Date: February 11, 2016
To: Mayor Kathleen Hoertkorn and Council Members
From: Heidi Scoble, Planning Manager
Subject: Cypress Trust Design Review Amendment, 38 Fernhill Avenue, File No. 2016-005

Town Council approval of Resolution 1936 to allow architectural design modifications, including the use of a cedar roofing material, for the new construction of a single family residence at 38 Fernhill Avenue, APN 073-041-37.

38 FERNHILL AVENUE
 ROSS, CALIFORNIA
 JANUARY 14, 2016
 PERMIT REVISION

A3.21

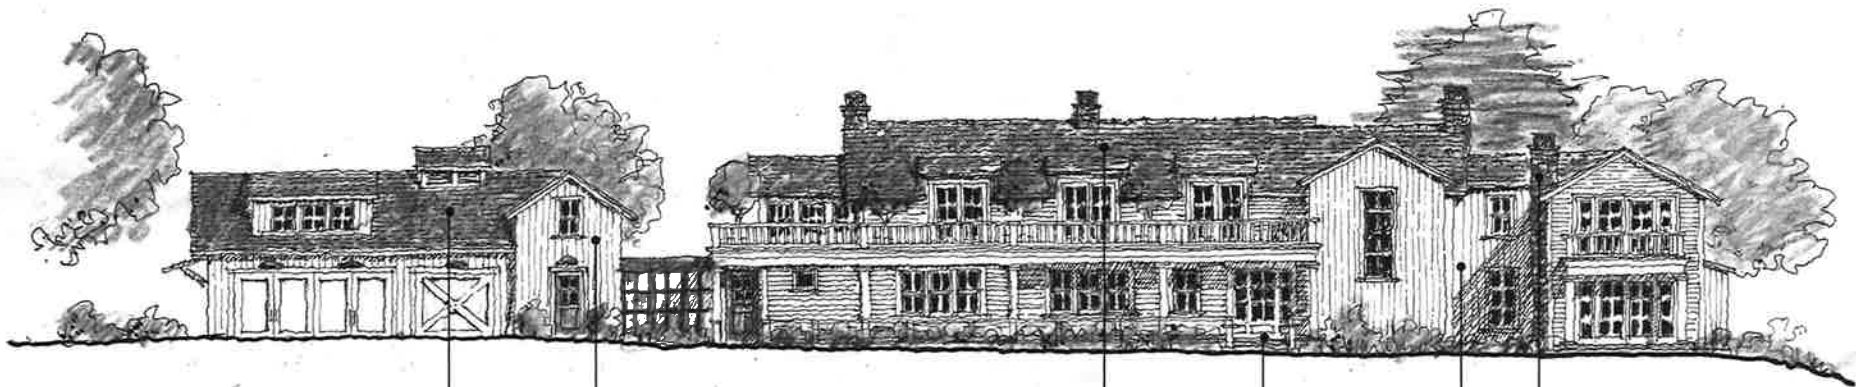
one area that warrants further discussion is the proposed cedar roofing material. The Town requires a Class A roof for all new construction. Although the applicant is proposing a Class B cedar shingles, the shingles would be treated with fire retardant material that would be installed over a 72lb mineral cap sheet over an asphalt-impregnated roofing felt underlayment, thus making Class A roof by assembly. A Class A roof by assembly is permitted by the building codes.

3. CEDAR SHINGLE ROOF
FIRE RETARDANT TREATED
CERTIGRADE "PERFECTION" GRADE1

A3.10

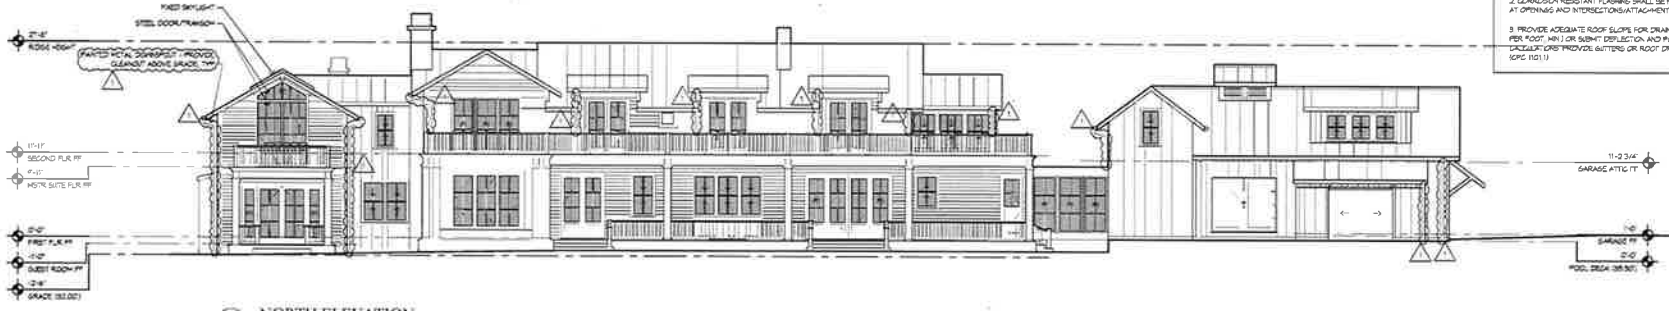
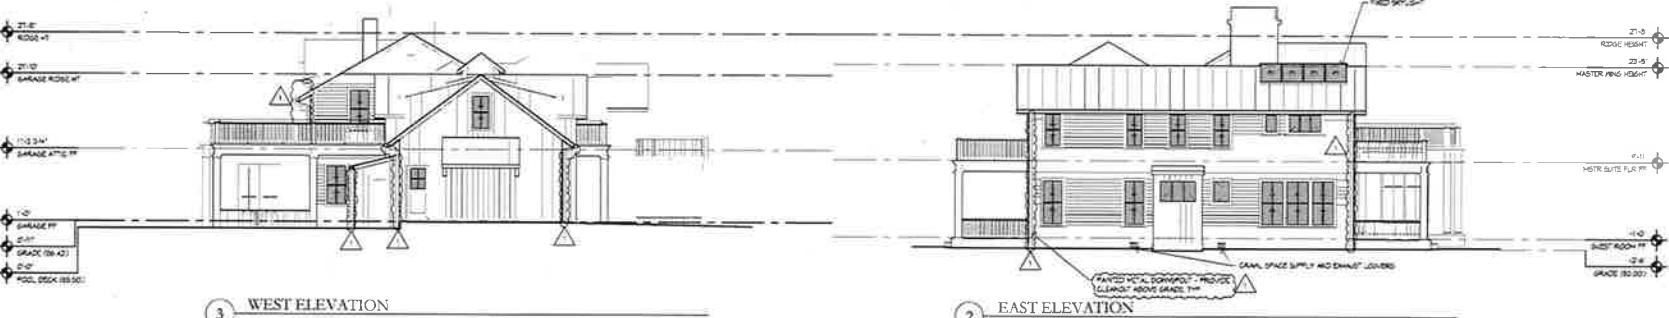
- ✓ Modify Exterior North Building Elevation
 - ✓ Window and door changes
 - ✓ Modify master wing second floor building wall and terrace
 - ✓ Installation of two reverse dormers

- Various minor responses to plan check comments
- Proposed downspout locations added to exterior elevations on A3.10, A3.11
